ADDENDUM NO. Three (3)
PROJECT NO: 112741
TITLE OF PROJECT: Headquarters HQ Replacement Phase 1
FACILITY LOCATION: Tyler State Park, Smith County, Texas

ADDENDUM NO. 3

Tyler State Park
Headquarters
TPWD Project Number 112741
FPC Project Number 92705
October 8, 2020

1 PROPOSED HEADQUARTERS
1" = 20'-0"

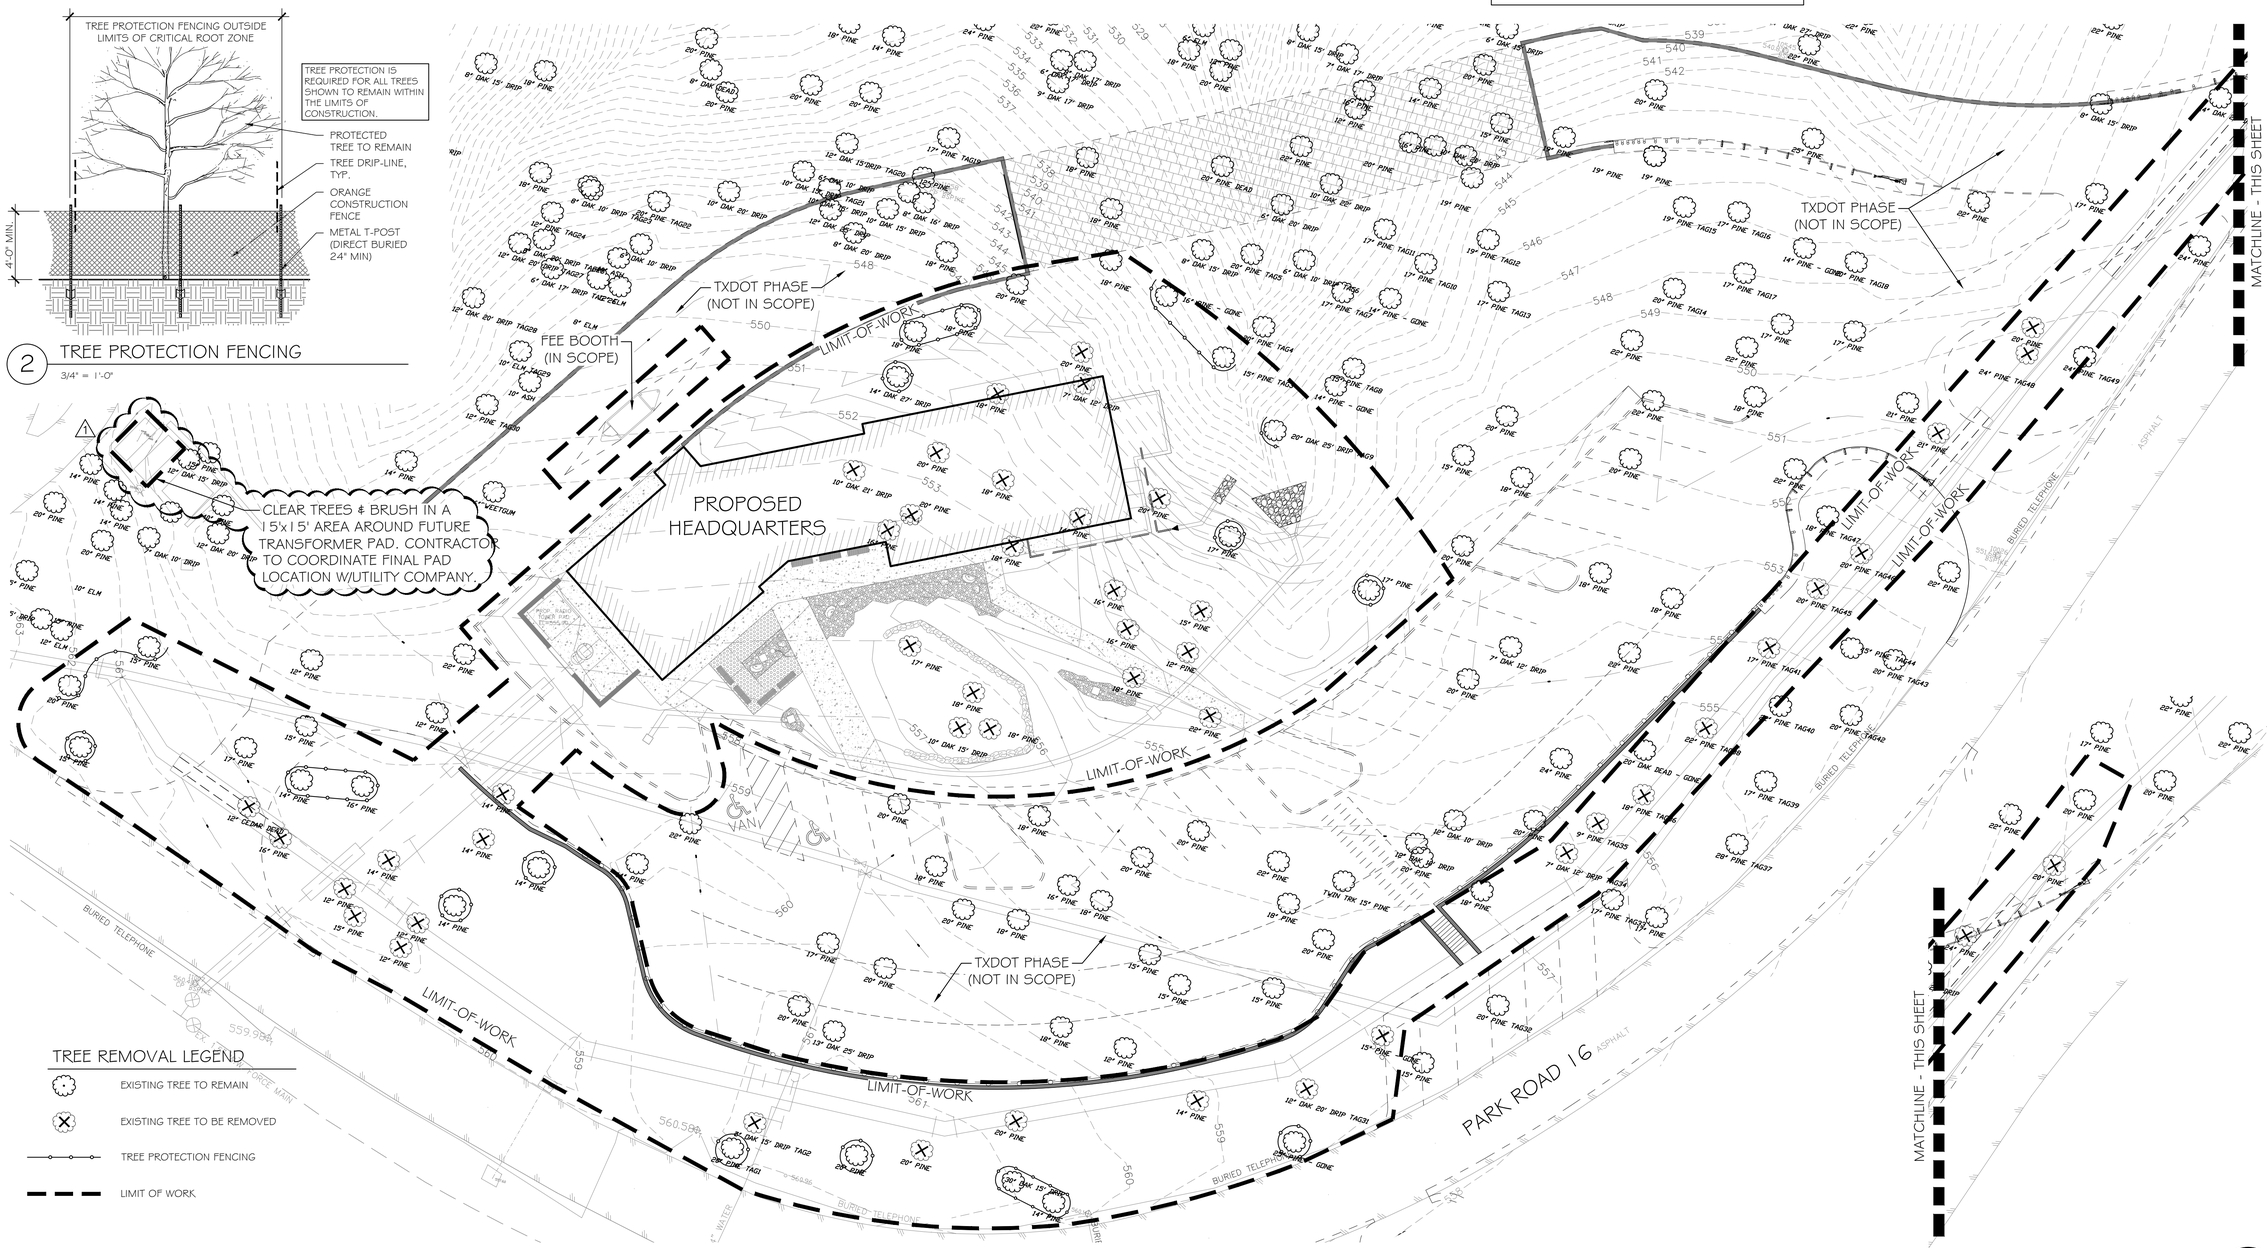
Item 3.02 Sheet L101 Tree Mitigation Plan (One 24 x 36 sheet)
Add tree clearing note at transformer pad

1 SITE PLAN
SCALE: 1" = 20'-0"

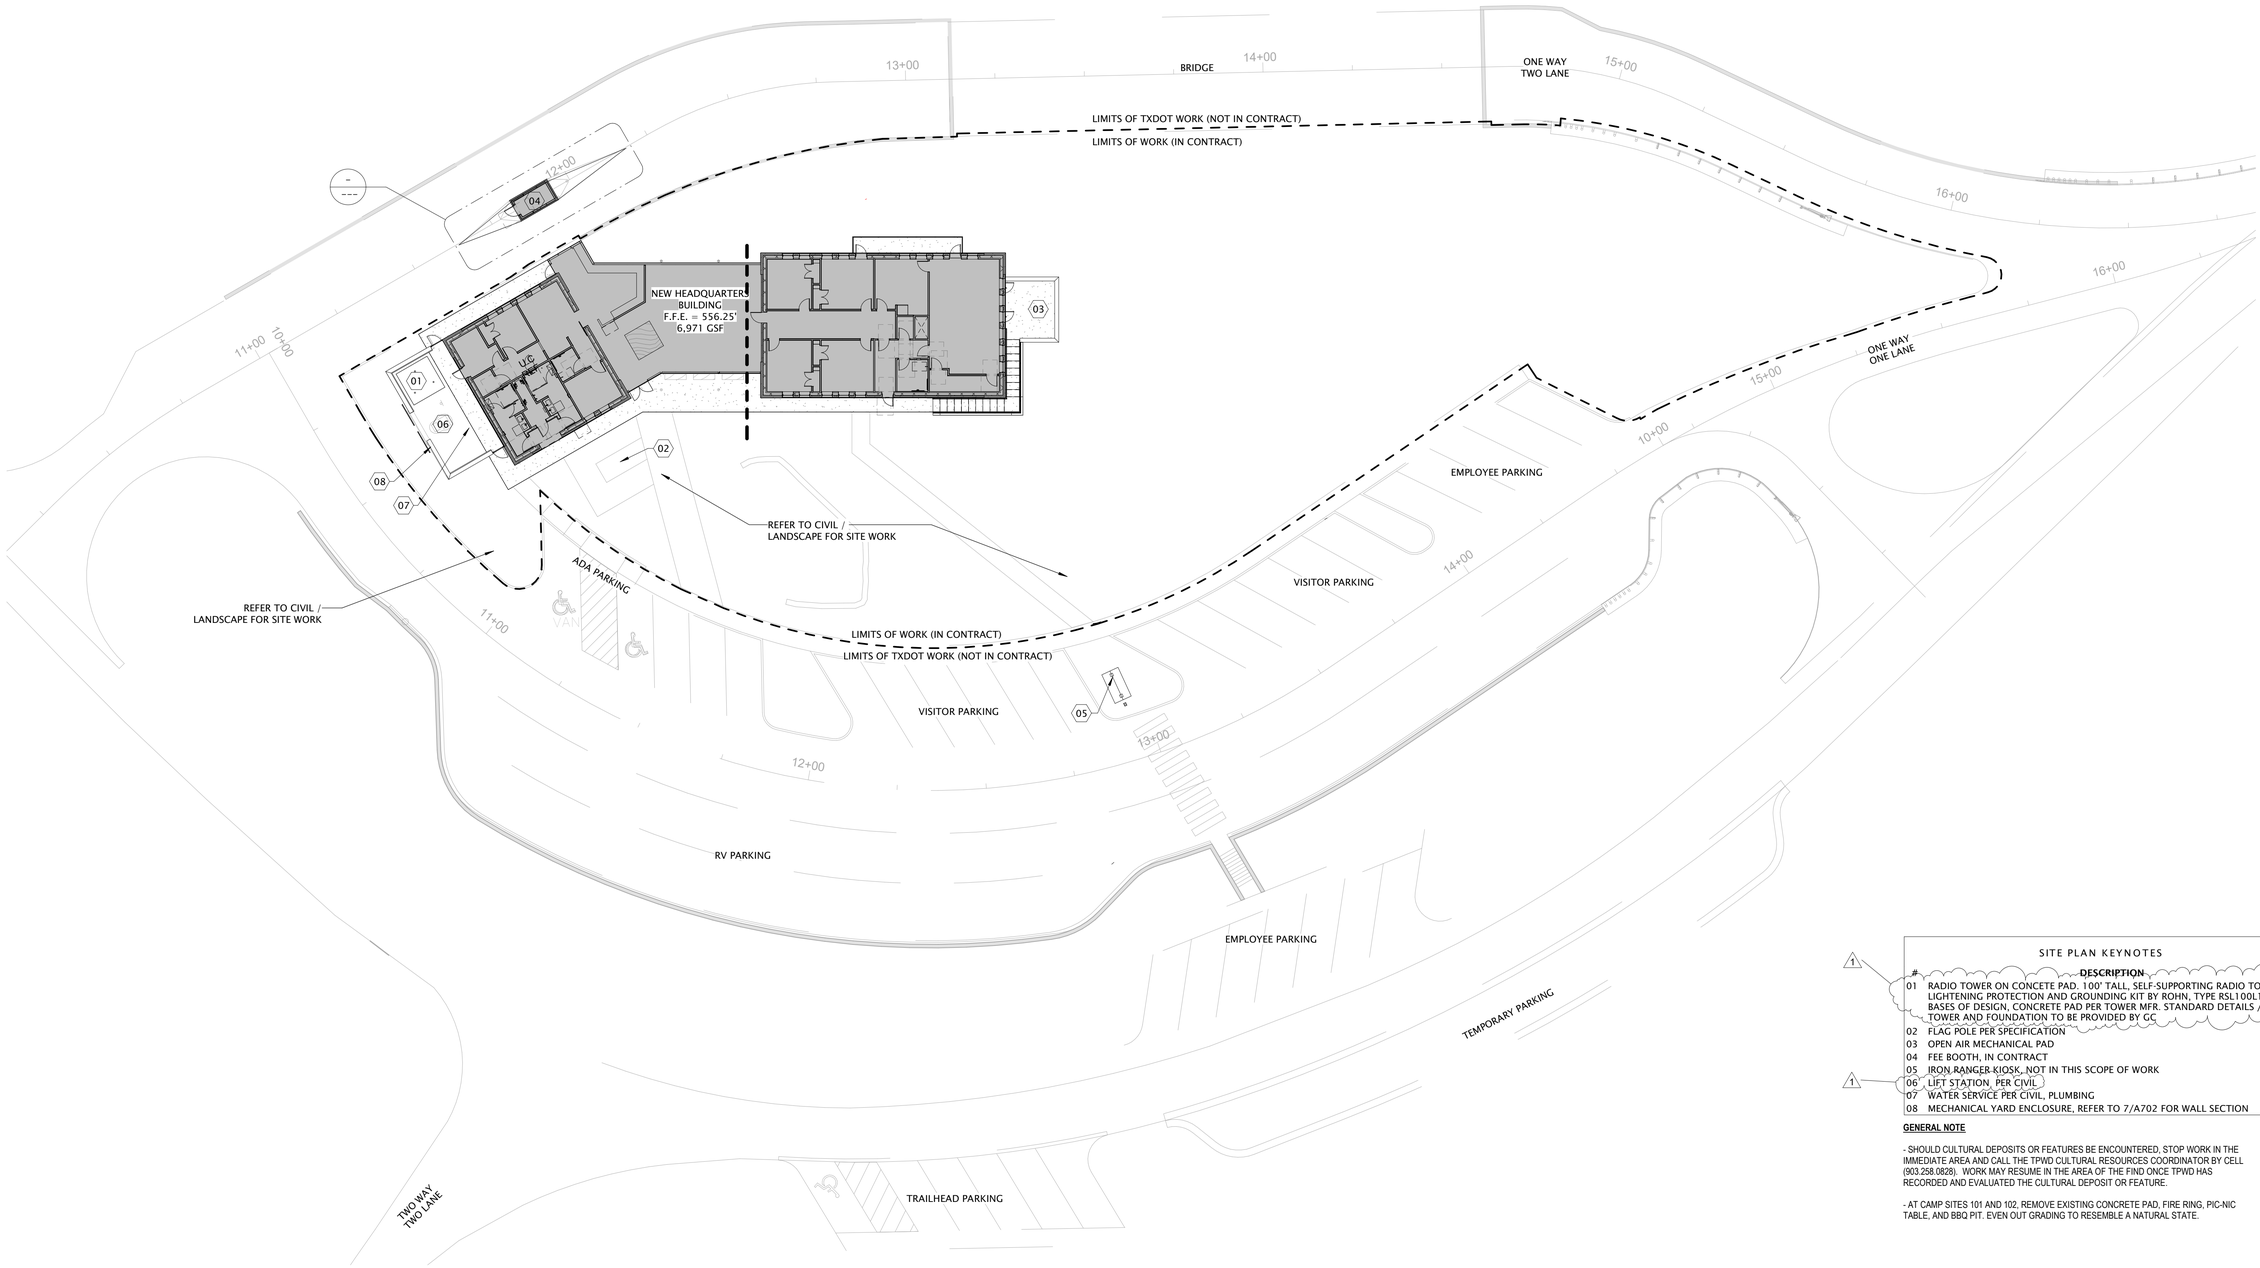
Item 3.03 Sheet A101 Site Plan (One 24 x 36 sheet)
Revise site plan key notes.

A10. Note on sheet A101 has been updated in addendum 03 to reference civil lift station

1 FIRST FLOOR OVERALL
SCALE: 1/8" = 1'-0"

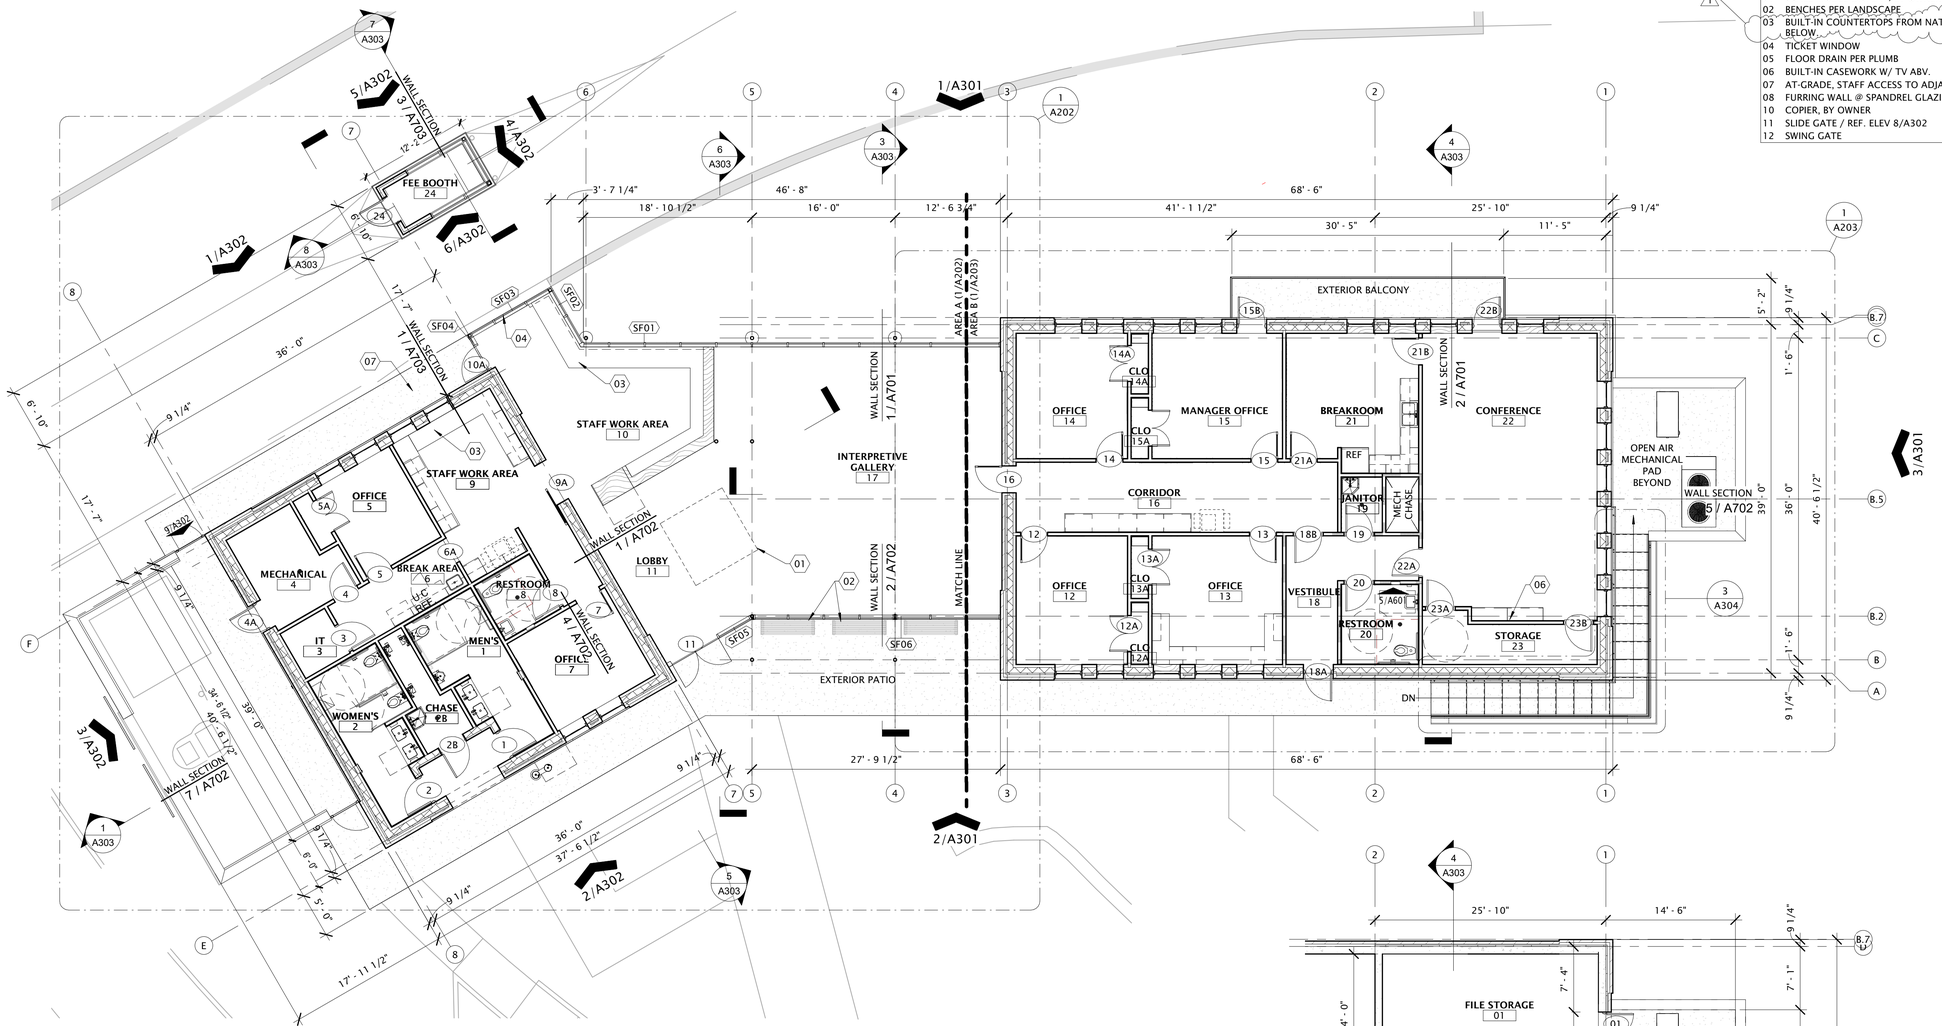
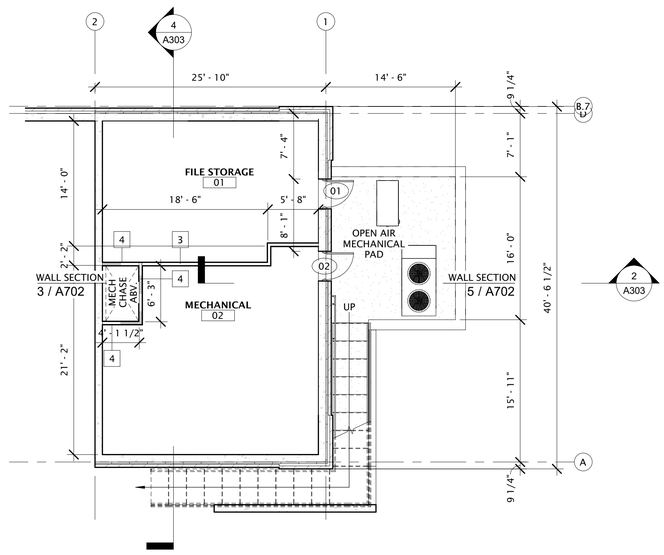
Item 3.04 Sheet A201 Floor Plans (One 24 x 26 sheet)
Revise floor plan key notes.
